Disinfection Alternatives
A Feasibility Level Design for the Laguna Wastewater Treatment Facility

Undergraduate Student, Humboldt State University

May 10, 2019

Figure 5: Current Laguna Wastewater Treatment Plant Schematic (SRCity 2016).

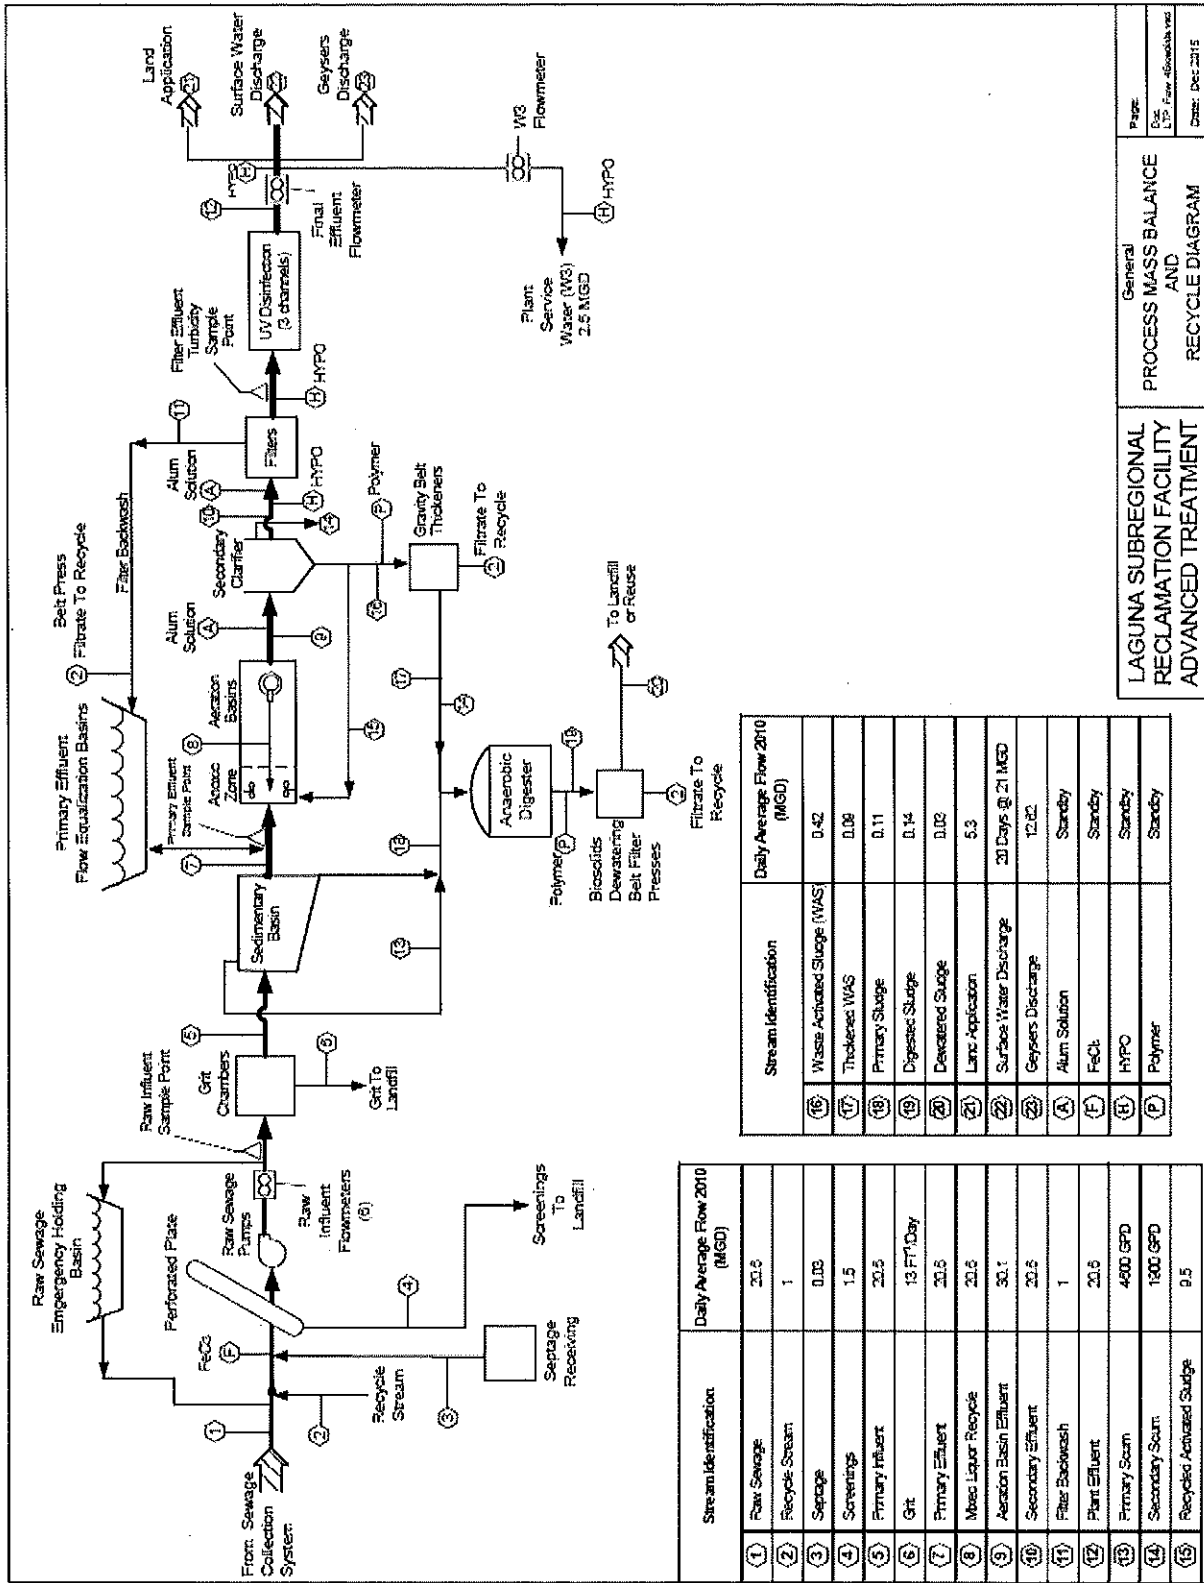
NITRIFIERS DON'T CONSUME ORGANICS THAT IS THE JOB OF THE CARBOXYLIC BACTERIA.

Figure 6: Potential project sites for disinfection upgrades at the Laguna Wastewater Treatment Plant (Google Maps, 2019).

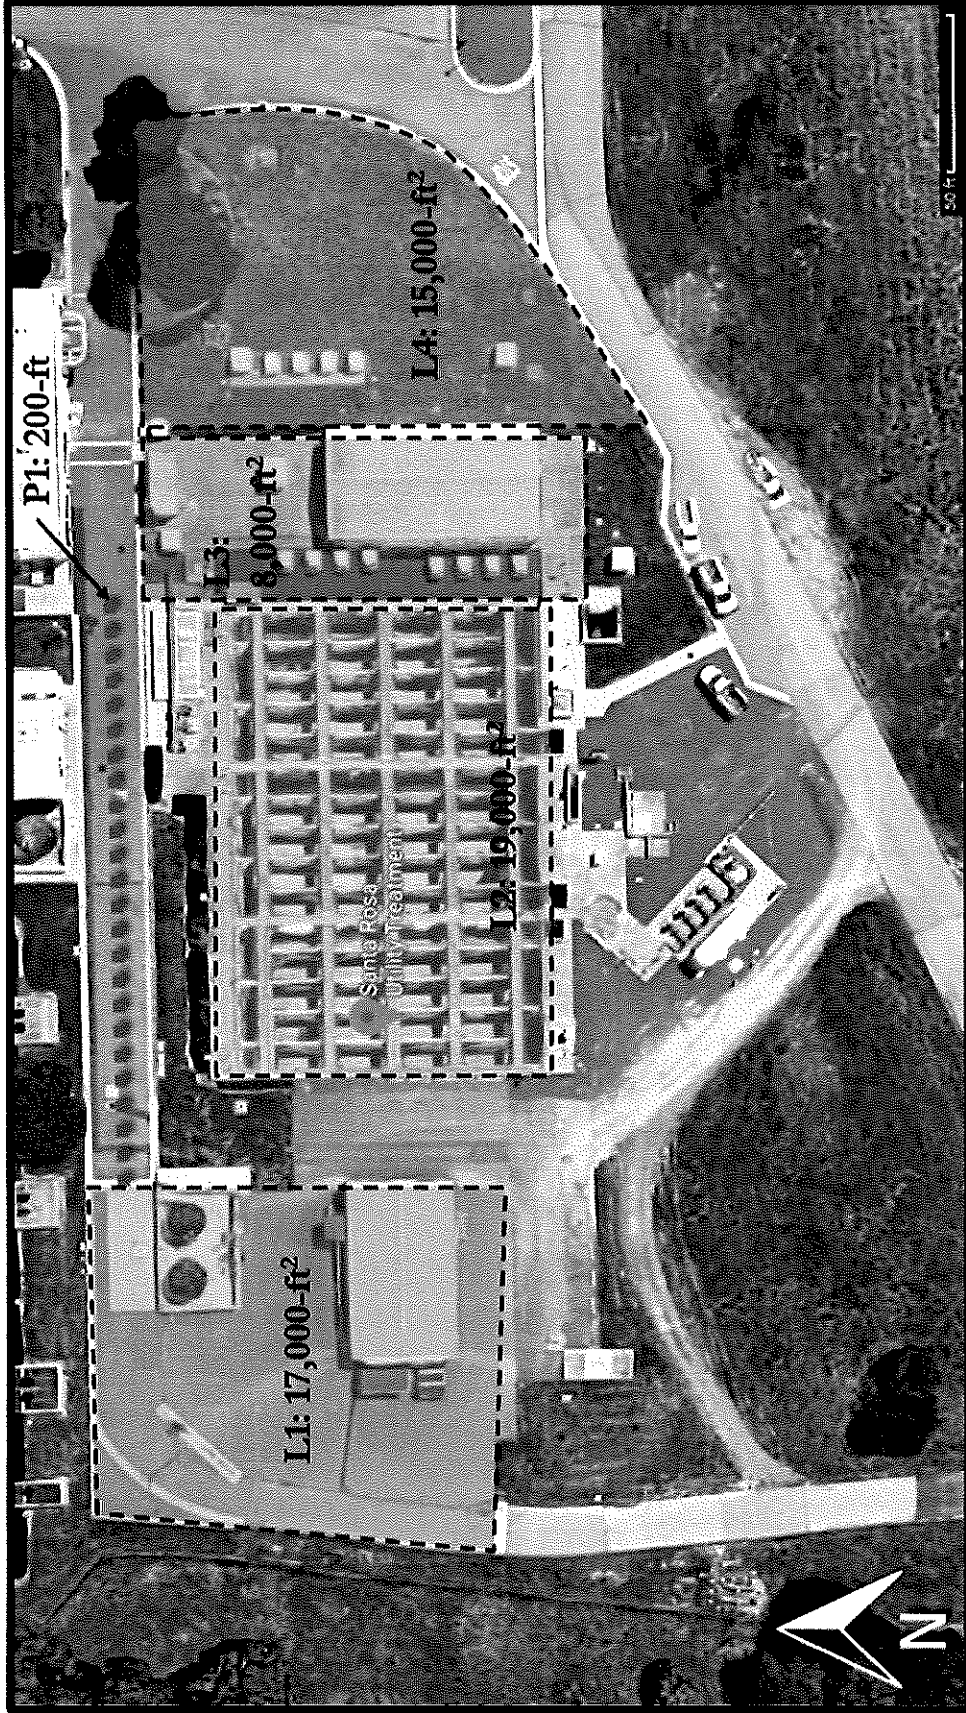
ANY EVIDENCE THAT CALIFORNIA STANDARDS NOT MET?
